ADA Curb Ramp New Construction Inspection Form (Parallel)

Nw 311 st

24952.54

Nw commercial st

PARALLEL RAMP (PL)

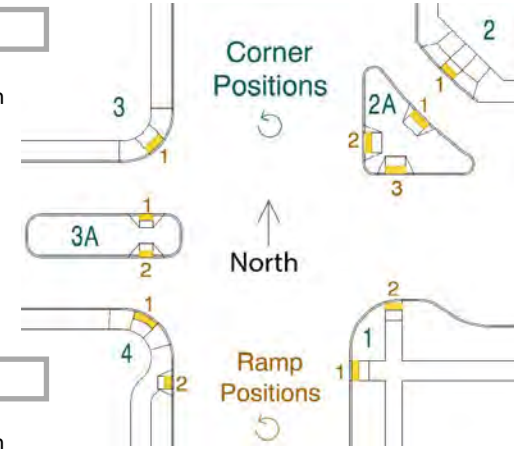
Cross Slope 2

2.9 $\leq 2.0\%$ ☐ $> 2.0\%$ ☒

Cross Slope 3

2.2 $\leq 2.0\%$ ☐ $> 2.0\%$ ☒
